PLANNING REPORT
SECTION 75W APPLICATION
MP 08_0195

78-90 OLD CANTERBURY ROAD, LEWISHAM
AMEND CONDITIONS AND MINOR CHANGES
TO CONCEPT PLAN

JANUARY 2013

12.2 MASTER PLAN (REV C) 9 NOVEMBER 2012

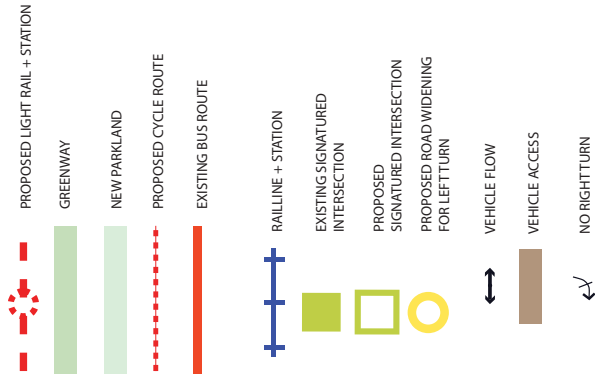
Amend Footprint of Buildings A and B

It is proposed to reconfigure the building footprints of Buildings A and B, in the space between those buildings. Currently, the approval provides for building footprints that cut through on a diagonal angle to the buildings. This does not provide for an efficient internal layout of apartments. Accordingly, it is proposed to change the angle to a right-angle.

The proposed amendments to the location of the parking access substantially increases the amount of space available for open space and landscaping. Amended Plan 12.2 and 22.1 show the increased open space.

12.4 SUBJECT SITE MASTER PLAN (REV C)
9 NOVEMBER 2012

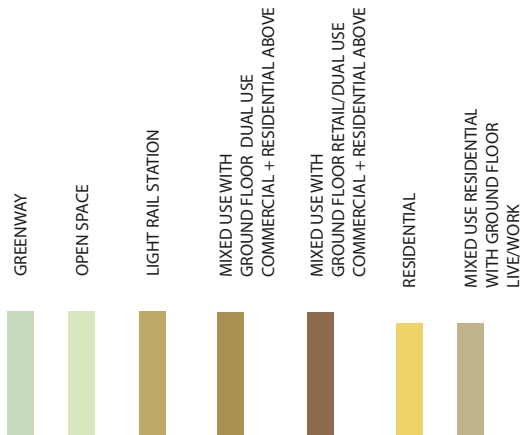
It is proposed to make minor amendments to the land uses plan.

The first amendment involves redefining the specific requirements for ground floor retail and commercial in Buildings A, C and G. It is proposed to introduce an allowance for 'dual use' spaces on those parts of those buildings. Dual use spaces are a 'universal' design practice that ensures a space can be used/easily adapted for either residential use or non-residential use. This practice allows important street level spaces to remain active/occupied. If retail space is in demand, the spaces would be used as such. In times of lower retail demand, the spaces could be occupied for residential purposes.

The second amendment involves deleting the requirements for non-residential landuse frontage towards the proposed north-south vehicular access ramp. It is not expected that any non-residential use would be successful in this location due to aspect and lesser pedestrian traffic.

12.5 SUBJECT SITE MASTER PLAN (REV C)

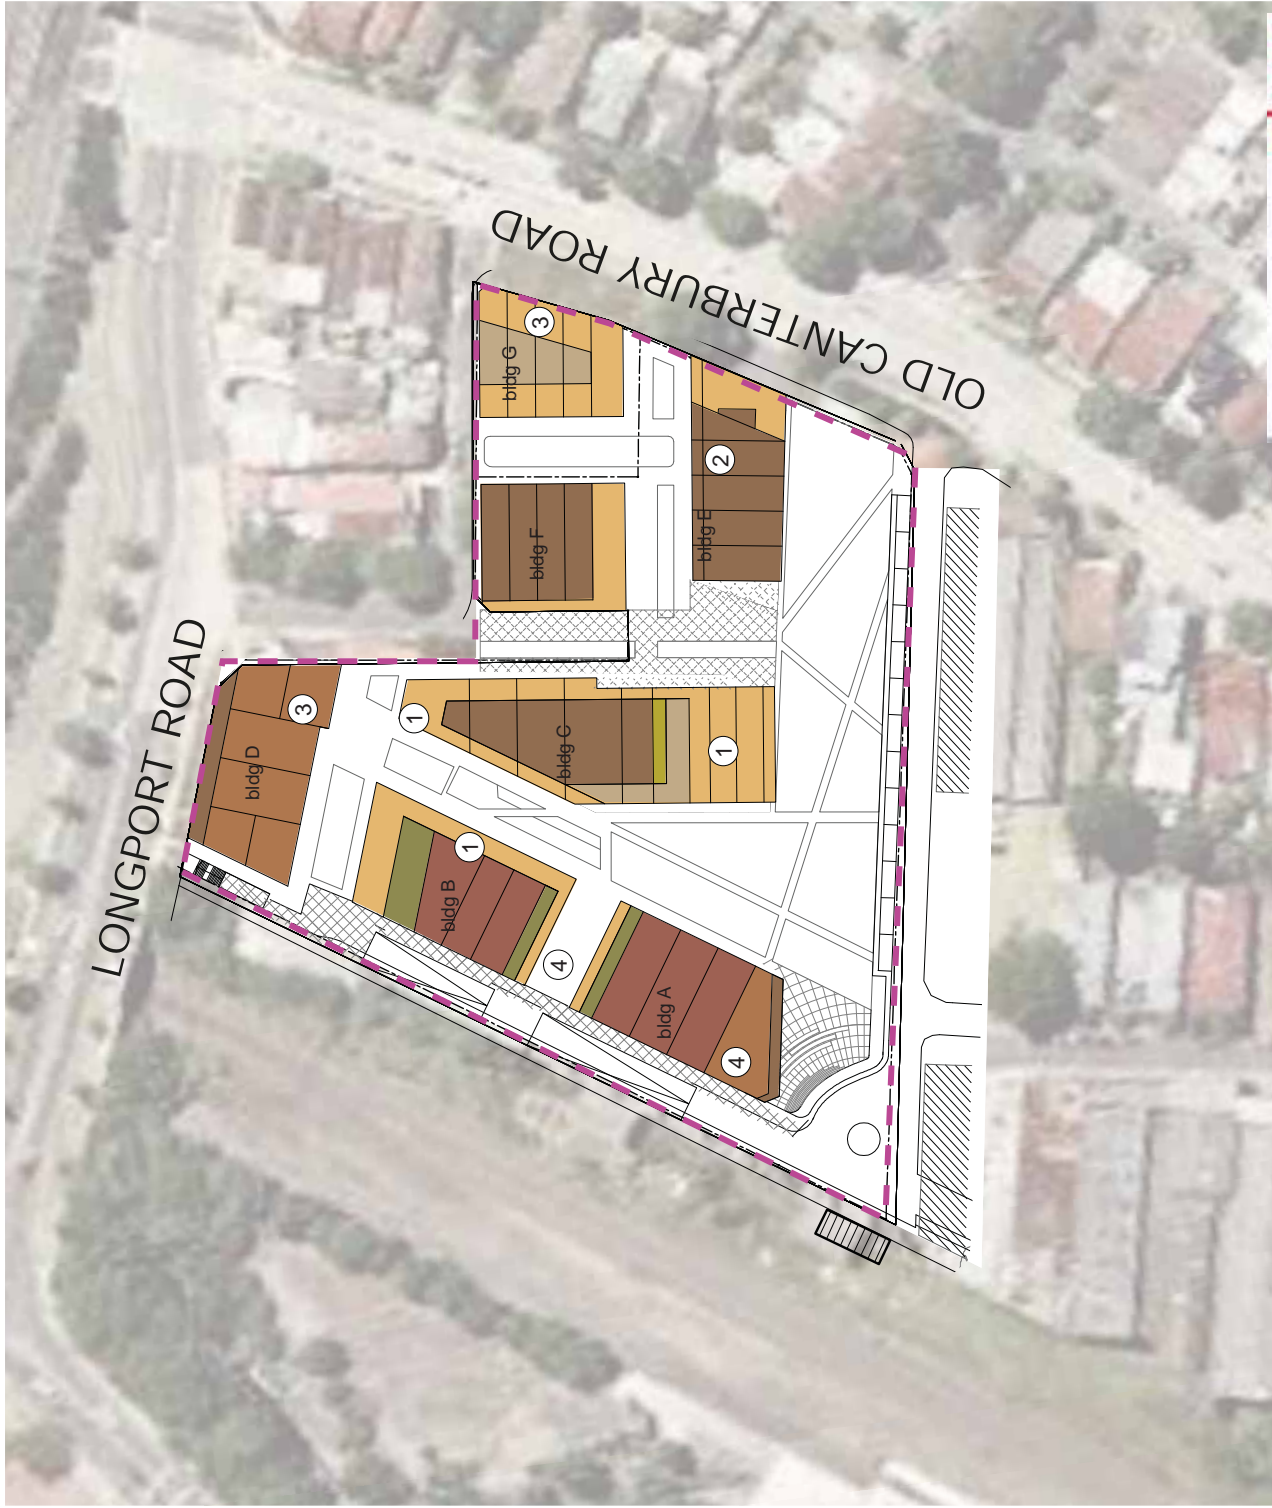
The amended plan 12.5 at **Annexure 1** contains numerical references on the plan and a description of the catalyst of the amended building form.

1. Reduction and massing adjustments to comply with solar access requirements for the public open space
2. Building core protrusion
3. Design development which remains within the consent setbacks
4. Reconfiguration of alignment, average is still the same

22.1_Green Space Calculation Analysis Proposed Concept Plan Green space Area Diagram

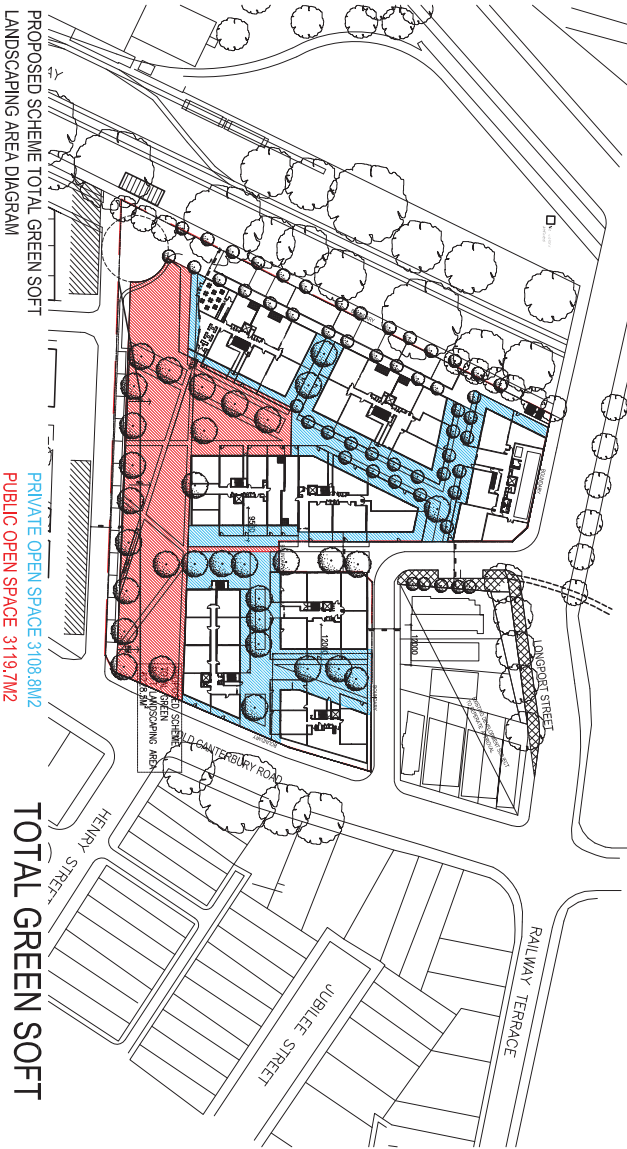
A total increase of 1,837.40 sqm of open space will result from the proposed amendments. The proposed overall amendments to the open space are shown in the table below.
